Work Order ID 162435

Item ID: D206-667-247TRN Accept ***N900040100*** Setup Start ***NS1***
 Revision ID: Stop ***NS2***
 Item Name: Crosstube Assembly, Mid Aft
 Start Date: 6/29/2017 Start Qty: 1.00 ***1*** Cust Item ID:
 Required Date: 7/6/2017 Req'd Qty: 1.00 ***1*** Customer:

DART AEROSPACE LTD HAWKESBURY, ONTARIO, CANADA	
DRAWING NO. D206-667-247	REV. A
TITLE CROSSTUBE ASS'Y (206L MID AFT)	SCALE NTS

DRAWING NO. D206-667-247	TITLE CROSSTUBE ASS'Y (206L MID AFT)	REV. A	DART AEROSPACE LTD ENGINEERING ORDER		D.E.O. NO. D206-667-247-A-1	SHEET NO. SHEET 1 OF 1	SCALE NTS
DRAWN <i>Q2</i>	CHECKED <i>ASS</i>	MFG. APPR. <i>KD</i>	APPROVED <i>IMP</i>		DE APPR. <i>#</i>		
DATE 11.07.15	DATE 11.07.20	DATE 11.07.21	DATE 11/07/21		DATE 11.07.21

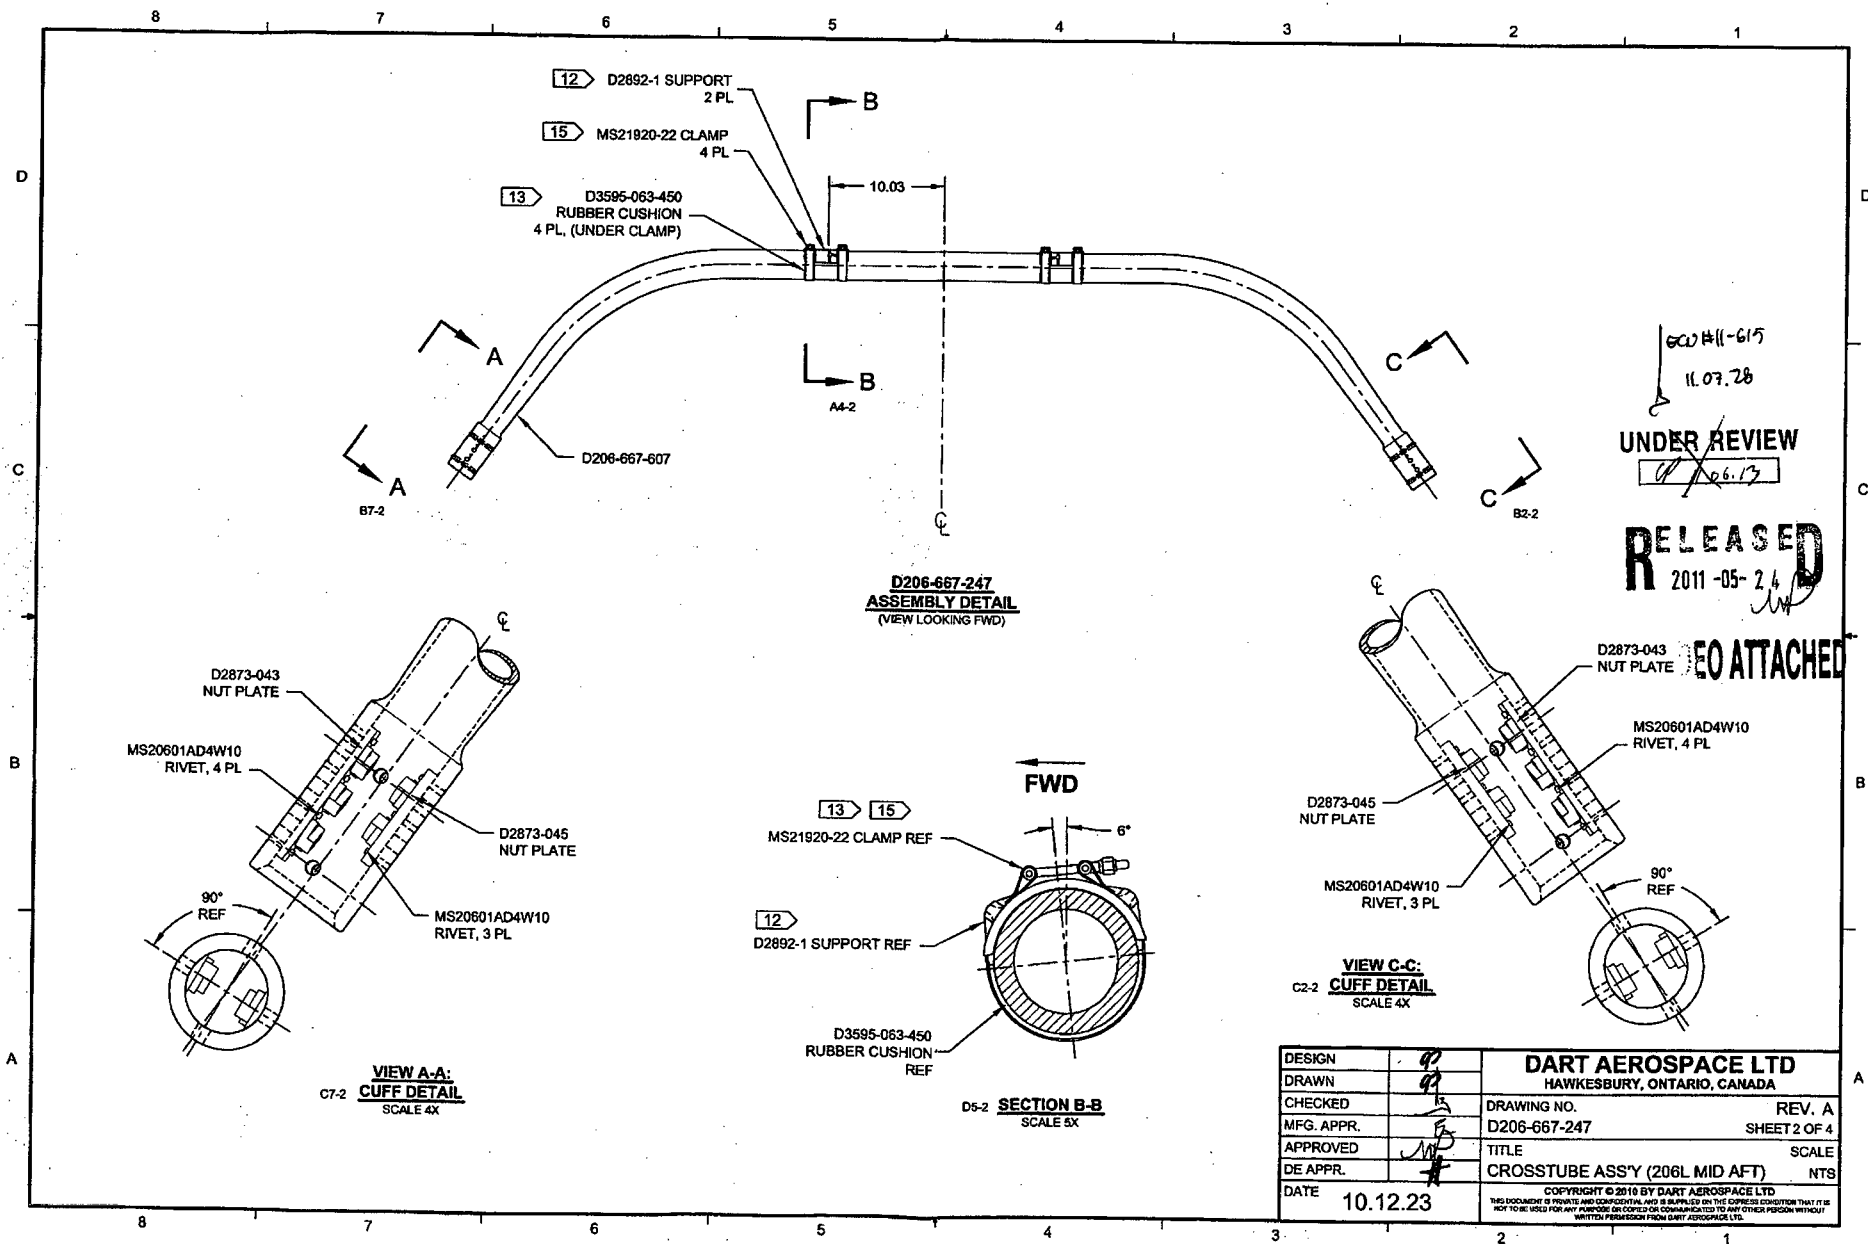
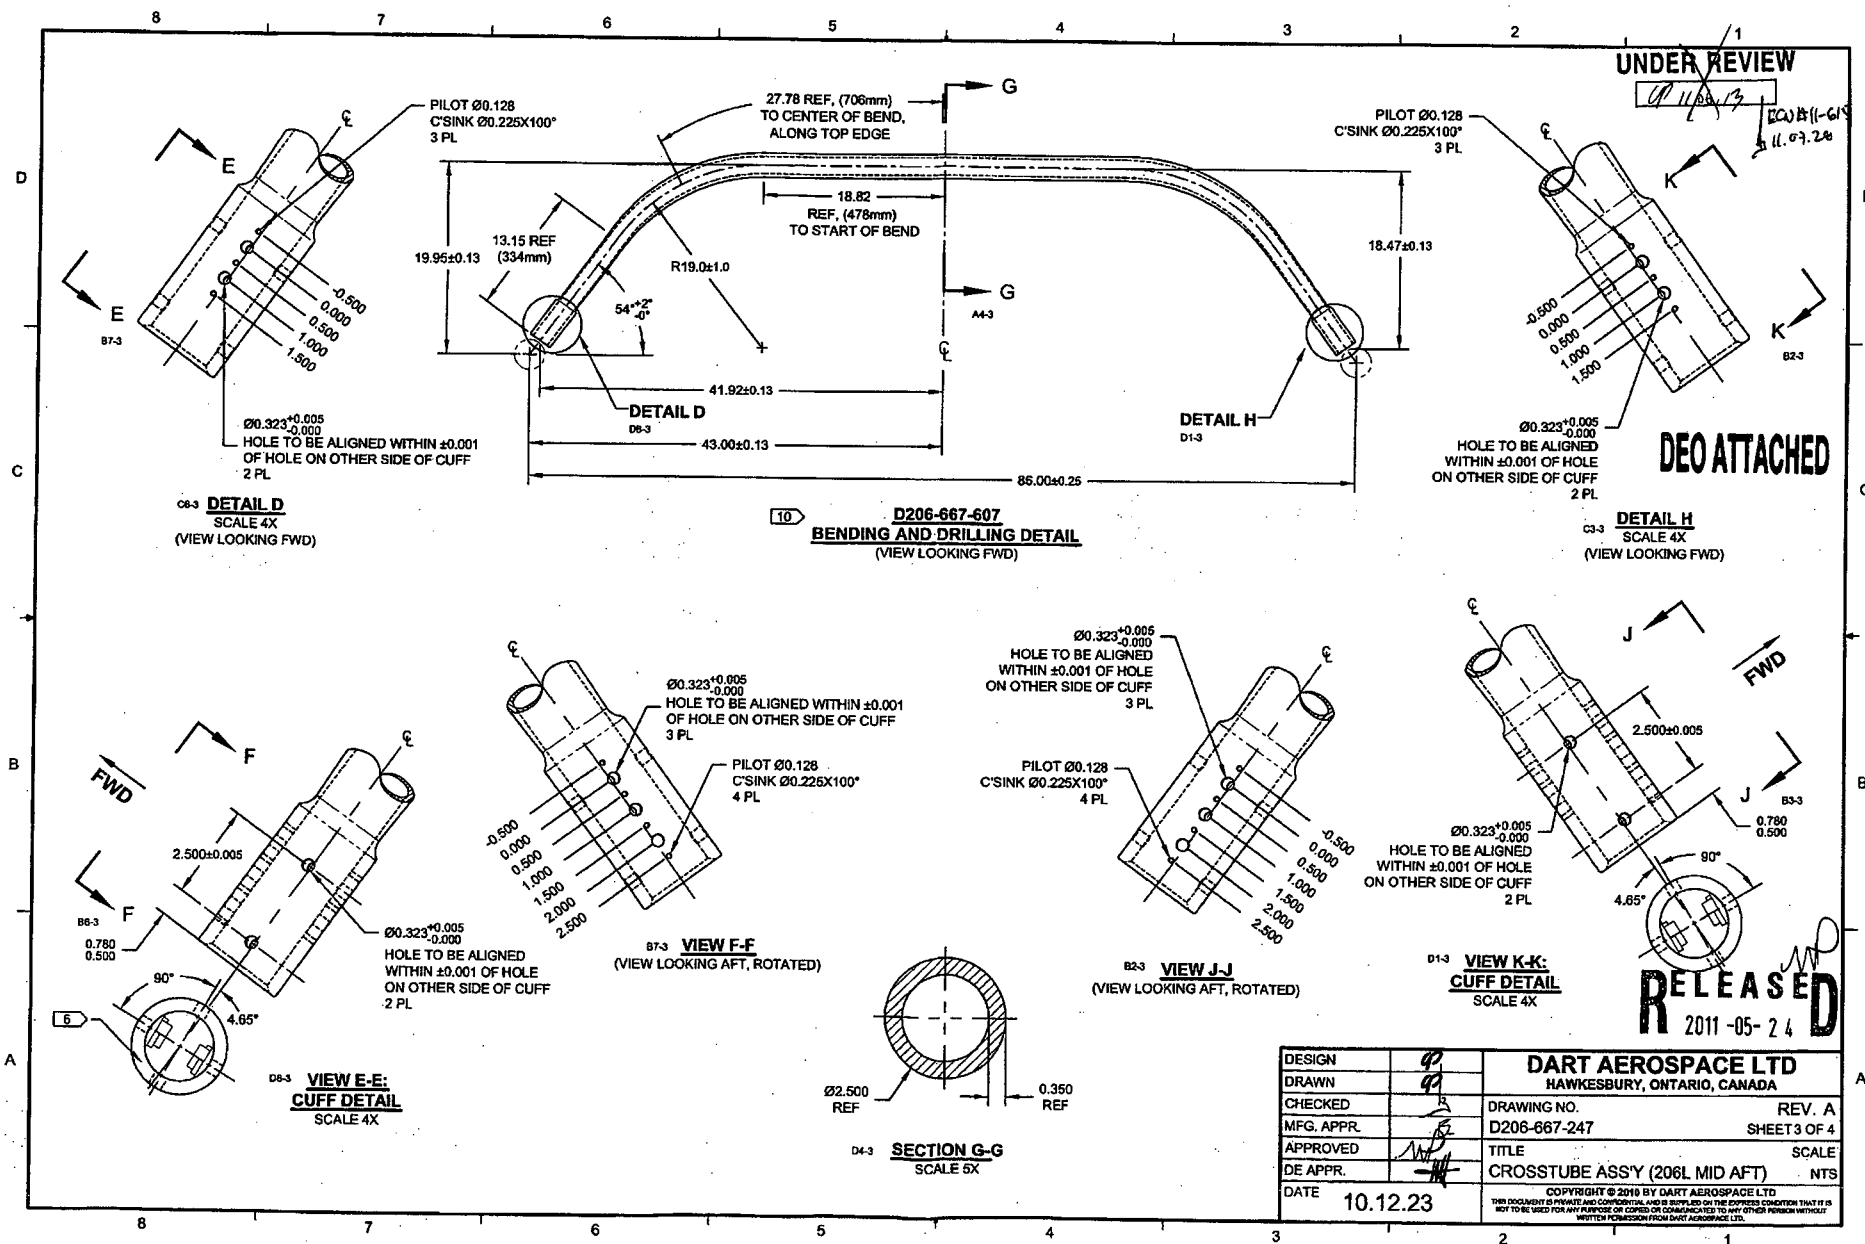
PURPOSE:

REPLACE MAGNOBOND WITH PROSEAL.

NOTE 12 & 15, SHEET 1 IS AMENDED AS FOLLOWS:

WAS:

12) INSTALL D2892-1 SUPPORT USING 0.03" TO 0.06" THICK LAYER OF MAGNOBOND 6398 PER QSI 015. LET CURE FOR 12 HOURS AFTER INSTALLATION AND PRIOR TO PACKAGING.

15) TORQUE CLAMPS 80 TO 100 IN-LB. ENSURE AT LEAST 1.5 THREADS SHOWING IN SAFETY AND THAT NUT HAS NOT BOTTOMED-OUT AFTER TORQUING.

Item	Qty -247	Part Number	Description
9	A/R	PROSEAL 890 B-2	SEALANT, AMS-S-8802 CLASS B-2

12) TO INSTALL D2892-1 SUPPORT: ABRAD MATING SURFACE OF SUPPORT AND CROSSTUBE WITH 180-GRIT SANDPAPER AND REMOVE RESIDUE WITH MEK (OR EQUIVALENT). APPLY A 0.04" TO 0.07" THICK LAYER OF PROSEAL 890 CLASS B-2 (OR AMS-S-8802 CLASS B-2) SEALANT TO MATING SURFACE OF SUPPORT.

15) TORQUE CLAMPS 80 TO 100 IN-LB. ENSURE AT LEAST 1.5 THREADS SHOWING IN SAFETY AND THAT NUT HAS NOT BOTTOMED-OUT AFTER TORQUING. **PRIOR TO PACKAGING, RE-CHECK TORQUE ON CLAMPS AFTER PROSEAL 890 SEALANT HAS CURED FOR 72 HOURS.**
